## ALPINE CITY PLANNING COMMISSION MEETING

**SUBJECT: Plat Amendment – Goeckertiz Plat C**

**Re: Goeckeritz Estates Plat C – Plat Amendment**

**NORTH POINT VIEW PLAT D**  
 SITE PLAN AND  
 GRADING AND DRAINAGE  
 1-2-19

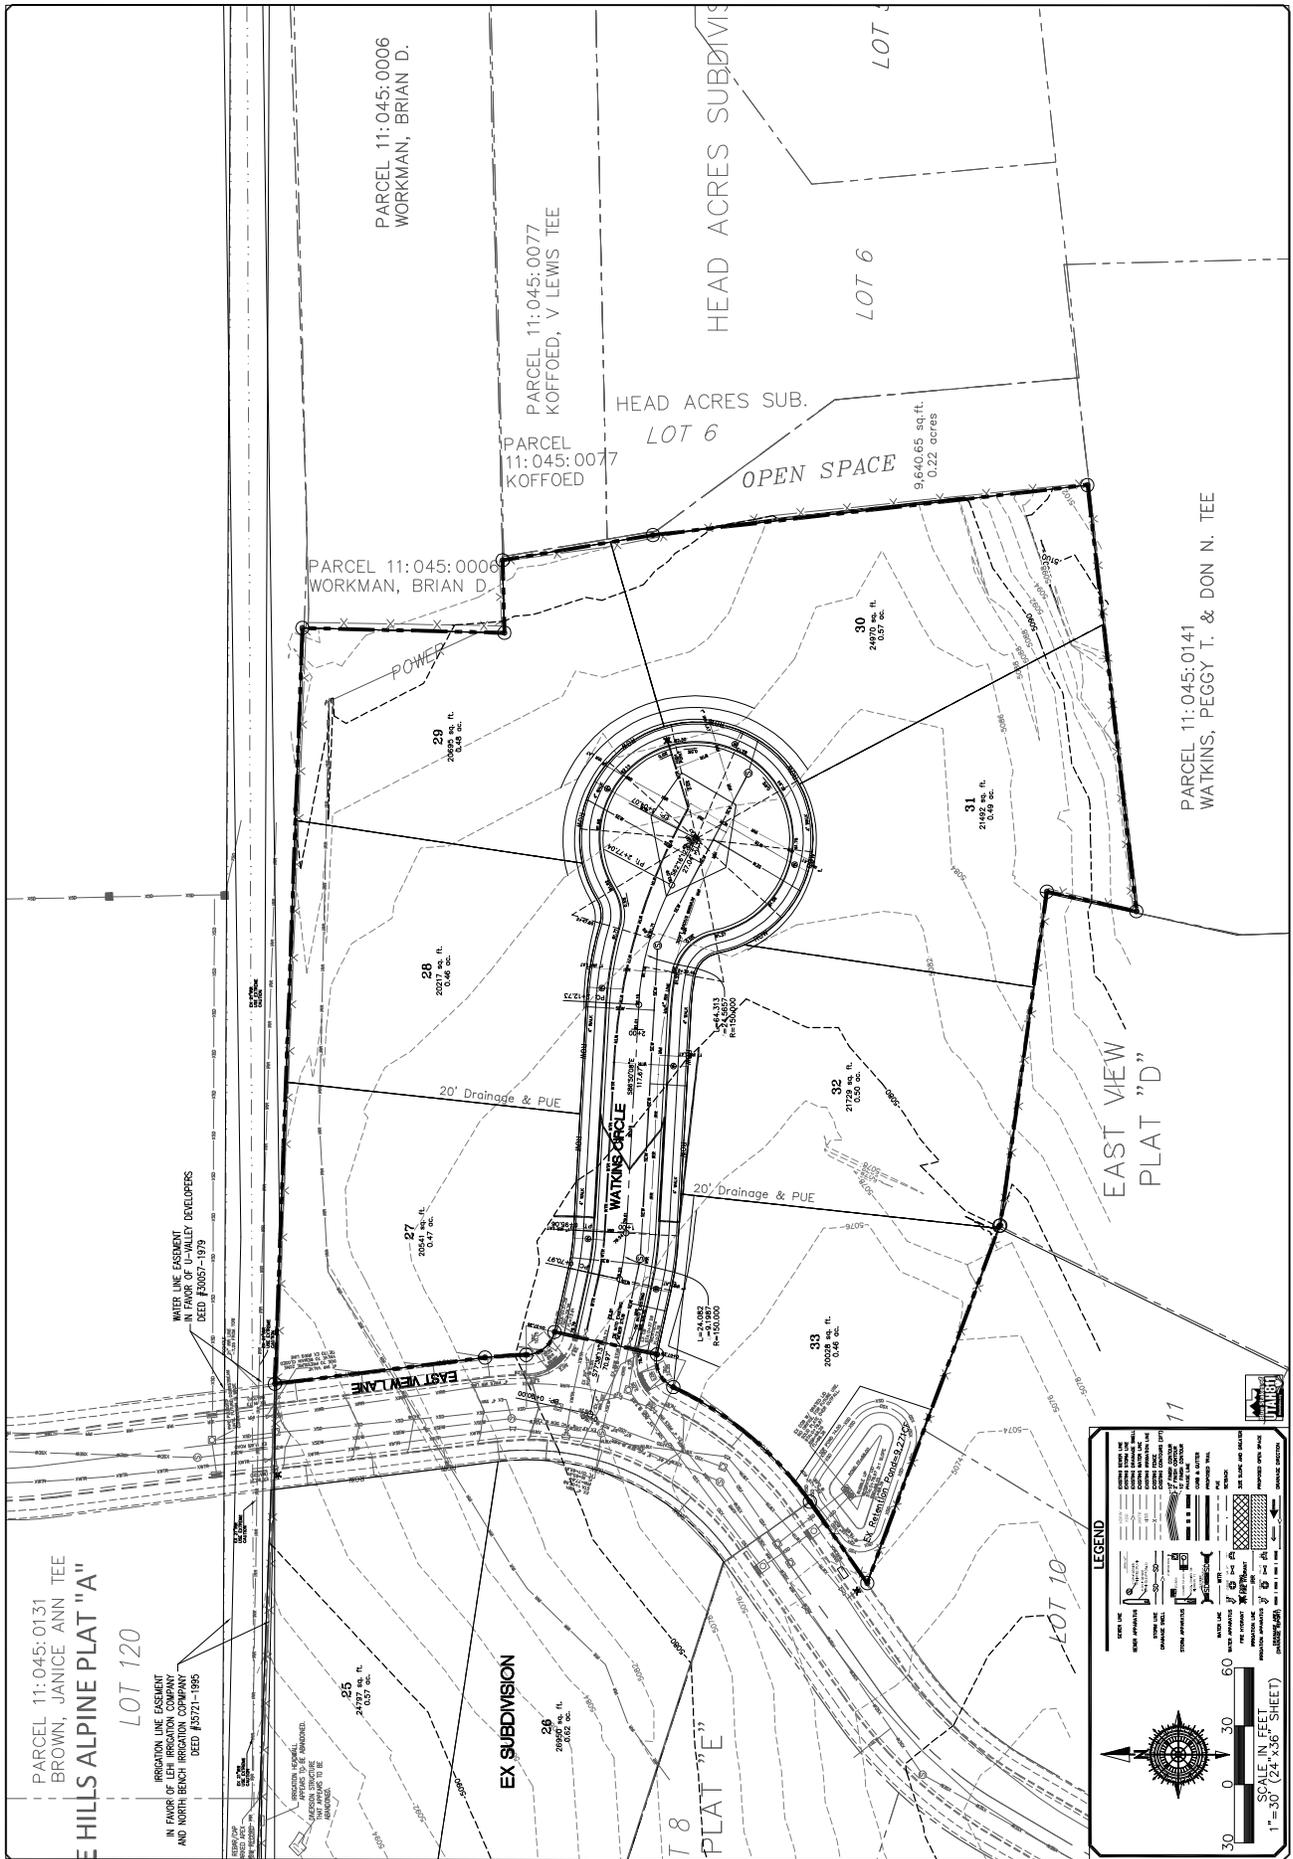
The North Field Ditch, owned by the Alpine Irrigation Company, runs along the easterly side of the property. City ordinance 4.7.19 requires irrigation ditches to be piped when development occurs where they reside. The plans do not show the ditch or piping thereof and would be required to do so prior to recording. **As a condition of approval, the Council should require plans for a piped ditch system be submitted and approved by Engineering as well as a 20-foot wide easement be shown on the plat for the alignment of said pipe.**

**There are redlines on plat and plans that would need corrected prior to recordation and construction.**

- The Developer submit plans for a piped ditch system, to be approved by Engineering, and show a corresponding 20-foot wide easement on the plat for the alignment of said pipe;
- The Developer seal the existing well on Lot 29 during construction;
- The Developer address redlines on the plat and plans;
- The Developer meet the water policy;
- The Developer remove all buildings that will conflict with future property lines (or provide a bond to do so prior to recording the plat.

ALPINE HIGHWAY

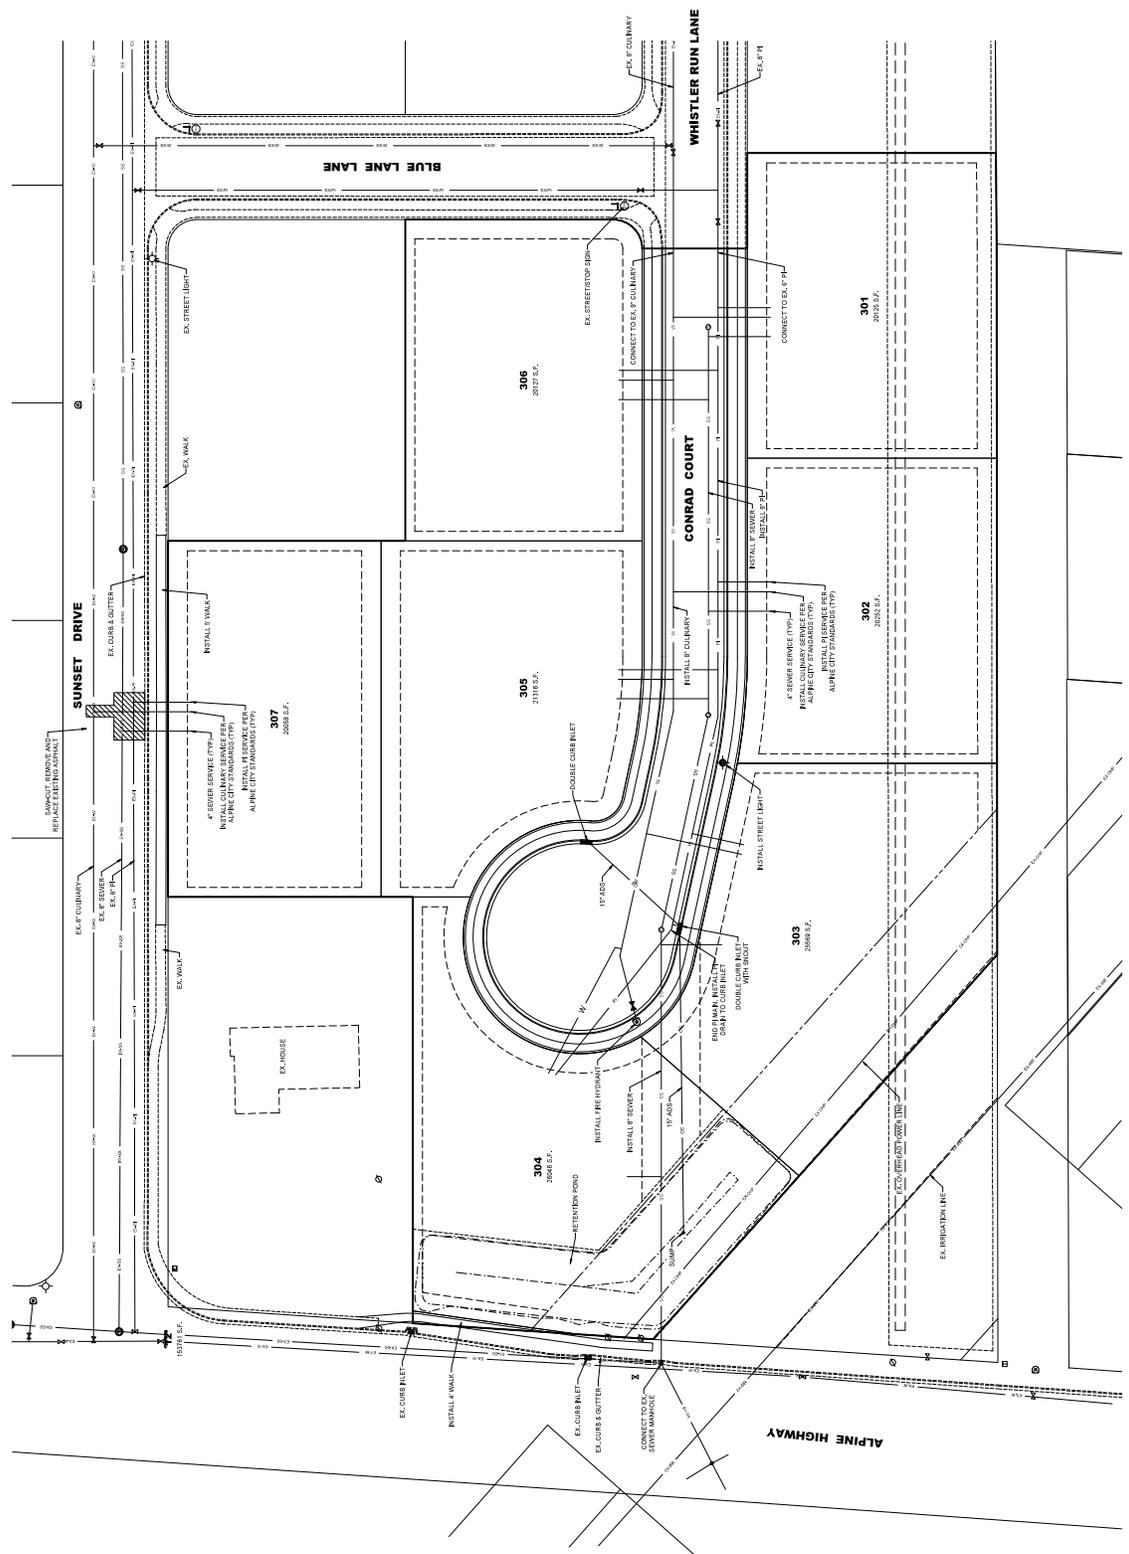
The sewer is shown to connect to existing lines in Alpine Highway. New service laterals are shown for each proposed lot. The sewer connection to Alpine Highway enters Metropolitan Water District (MWD) property to make the connection. An inquiry with the MWD about the connection revealed that this connection would cost the City \$1700 every 25 years, plus land use fees. No amount was given regarding the land use fees but from past experience in other parts of town we know these fees can be substantial. **Approval of the plan as proposed would need to be conditioned that the City Council agrees to the fees associated with the connection.** The Developer may be seeking another option for connection but Staff has not seen that yet. Lot 307 will acquire its services from the existing utilities in Sunset Drive. Horrocks Engineers has modeled the proposed development and the correct line sizes are shown on the plans per the master planned models.

**There are redlines on plat and plans that would need corrected prior to recordation and construction.**

- The City Council agrees to charges incurred by a sewer connection on Metropolitan Water District property OR the Developer provide a design that does not cost the city annual charges;
- The Developer address redlines on the plat and plans;
- The Developer meet the water policy;
- The Developer remove all buildings that will conflict with future property lines (or provide a bond to do so prior to recording the plat);
- The back of Lot 304, a double frontage lot, be landscaped where possible and as permitted given possible limitations due to the easement and storm drain pond.
